GAVA Private Limited

Plot # 114-120, Dhaka Export Processing Zone (old area),
(23.948083, 90.272639)

26 August 2025

Observation 6: The load plan doesn't comply with BNBC (Main Factory Building).

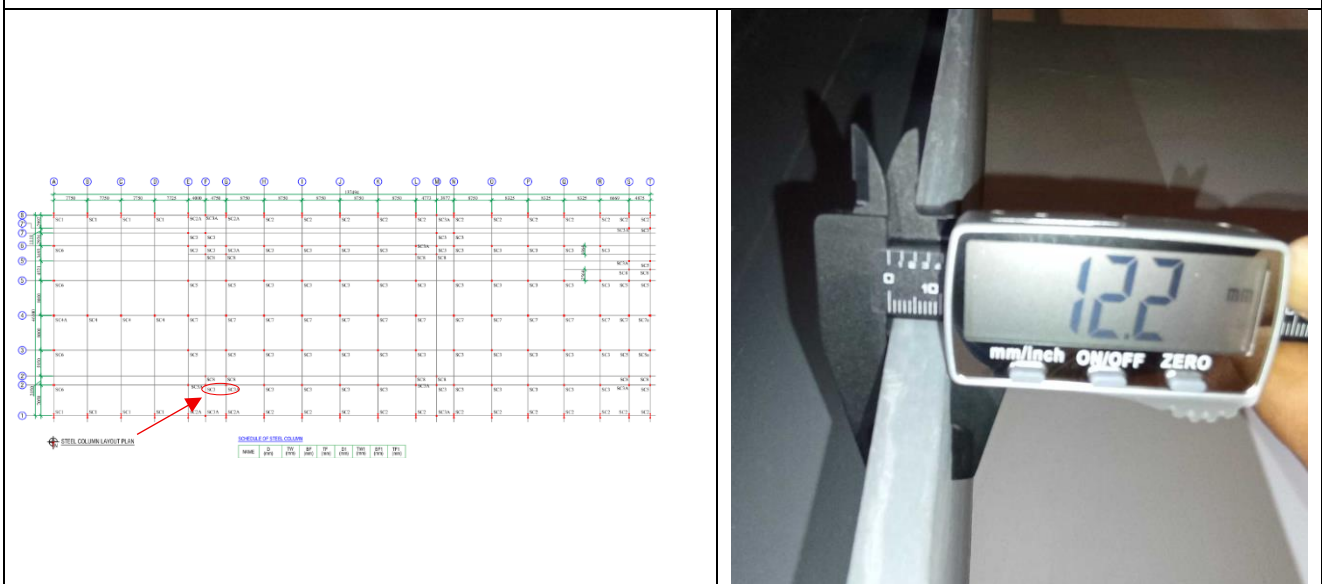
LOADING FOR THIS FLOOR				
NO.	TYPE	ITEM	MAX. LOAD IN PSF	DESCRIPTION
01	LIGHT	SAMPLE AREA	63	TYPICAL MACHINE
02	LIGHT	CAD ROOM	63	TYPICAL FURNITURE
03	LIGHT	OFFICE	63	TYPICAL FURNITURE
04	LIGHT	MAINTENANCE	63	TYPICAL MAINTENANCE AREA
05	LIGHT	TOILET	42	TYPICAL TOILET
06	LIGHT	STAIR	100	TYPICAL STAIR

Occupancy or Use	Uniform kN/m ²	Concentrated kN
Hotels	See Residential	
Libraries		
Reading rooms	2.90	4.50
Stack rooms	7.20 ^d	4.50
Corridors above first floor	3.80	4.50
Manufacturing*		
Light	4.00	6.00
Medium	6.00	9.00
Heavy	12.00	13.40
Garments manufacturing floor except stacking or storage area	4.00 ^e	--
Stacking or storage area of garments manufacturing industry	6.00 ^f	10.00 ^f

9.	The load plan doesn't comply with BNBC (Main Factory Building).	The factory engineer is required to revise the load plan as per the BNBC requirement and check the design accordingly.	within 6 weeks
